World Forum for Harmonization of Vehicle Regulations**Working Party on Automated/Autonomous and Connected Vehicles****Twenty-first session**

Geneva, 20-24 January 2025

**UN Regulations Nos. 13, 13-H, 139, 140 and UN GTR No. 8:
Clarifications****Proposal for amendments to UN Regulation No. 13 (Heavy
vehicle braking)****Submitted by the experts from the European Association of Automotive
Suppliers ***

Diagram 2

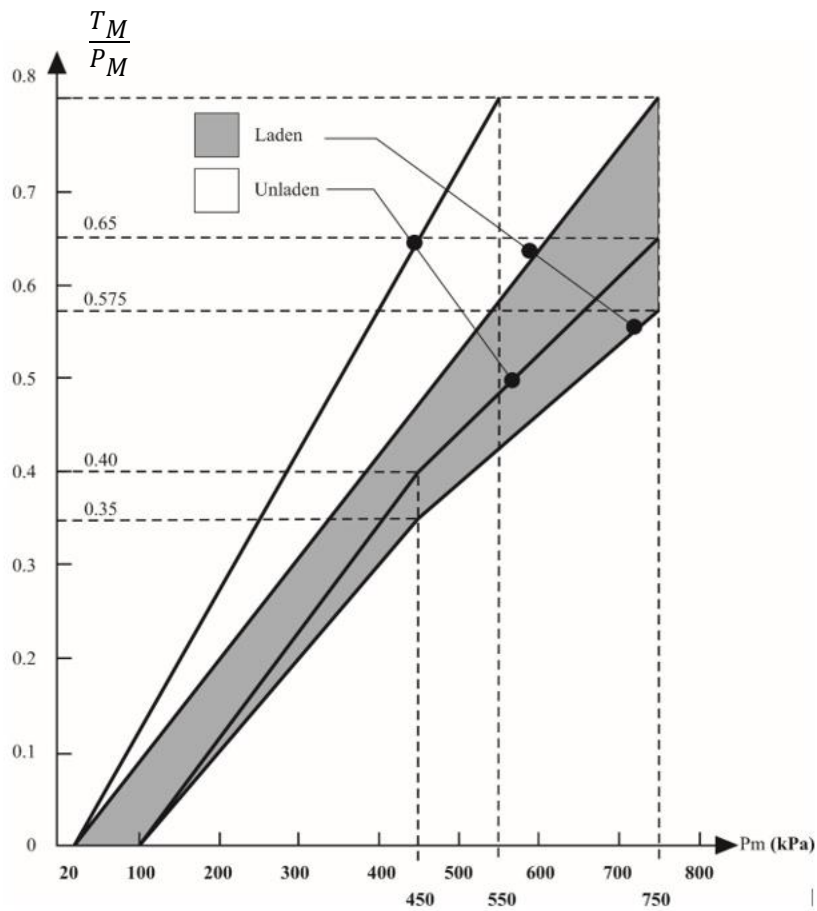
Annex 10, Diagram 2, title, amend to read:

(except tractors for semi-trailers ~~and semi-trailers and full trailers~~)

Diagram 4A

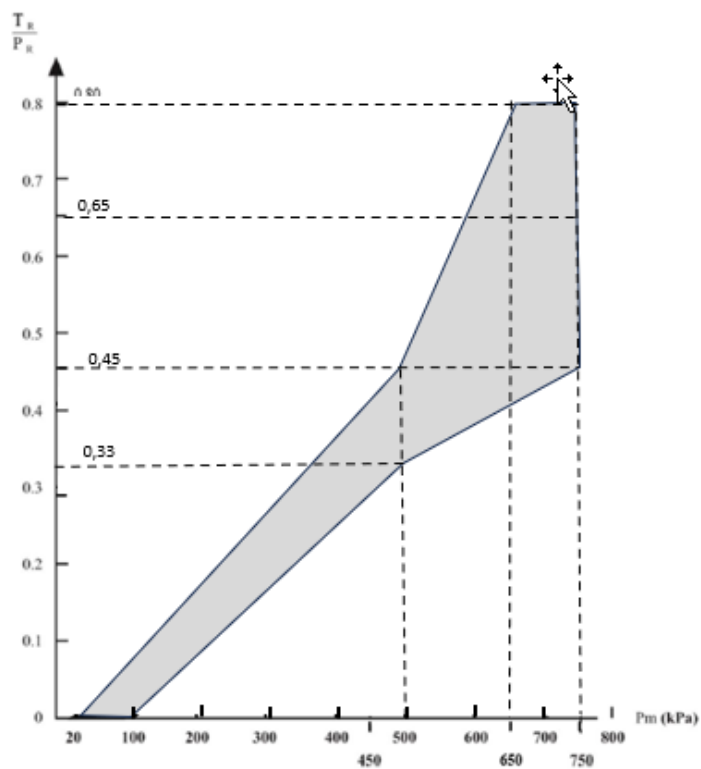
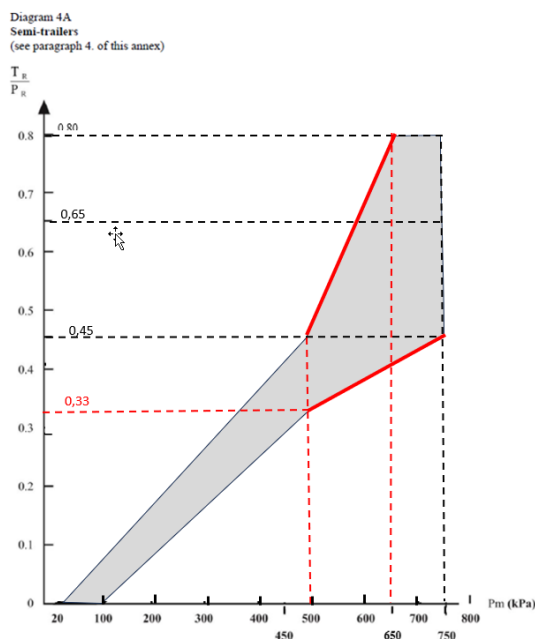
Annex 10, Diagram 2 and Diagram 4A, amend to read:

(a) Extension of the compatibility bands at higher control pressure ($p_m \geq 500$ kPa) by modification of diagram 4A for semitrailers and adding a new diagram 5 for full trailers instead of using diagram 2 for towing vehicles.

Diagram 5
Full trailers and centre-axle trailers
 (see paragraph 5 of this annex)

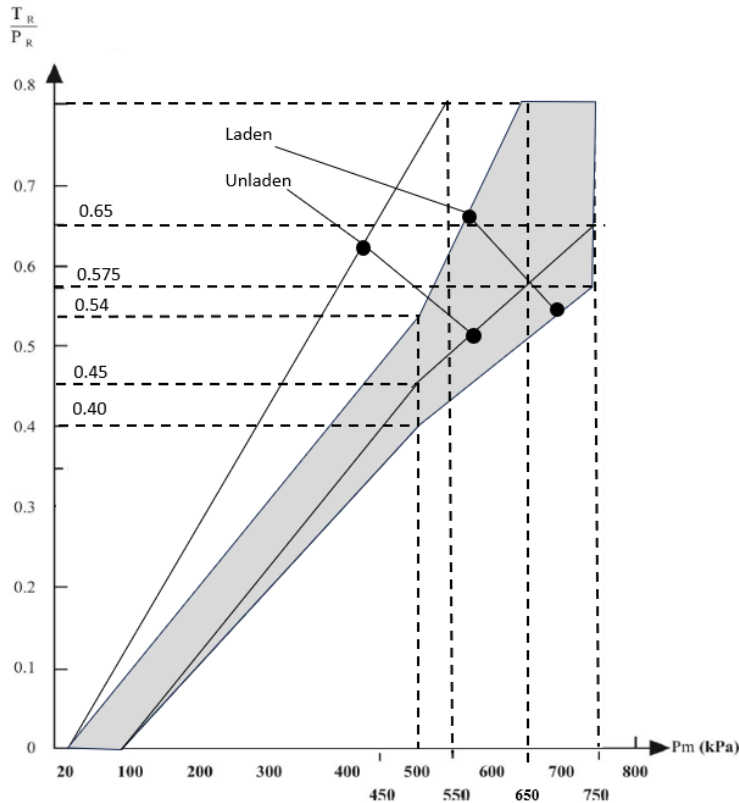
Insert a new diagram 5, as follow:

Current diagram 2 for Trucks & trailer

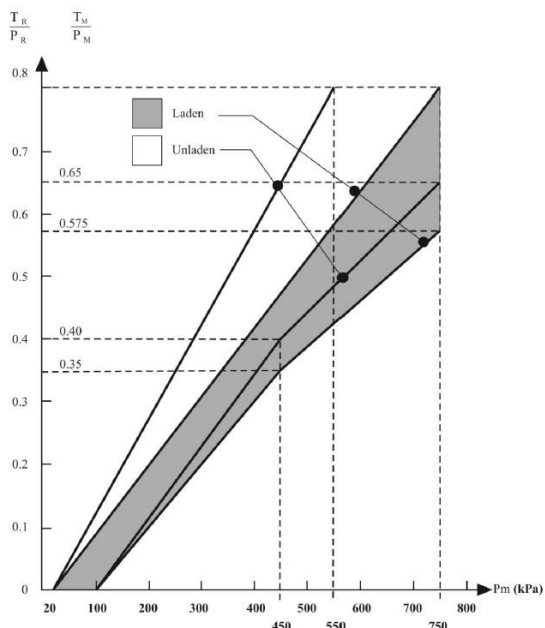
(c) On the other hand, the maximum brake force, which may be installed in trailers is limited by the upper line of the compatibility band as currently shown in diagrams 2 (for truck and full-trailer) and 4A (for semi-trailer) of Annex 10.
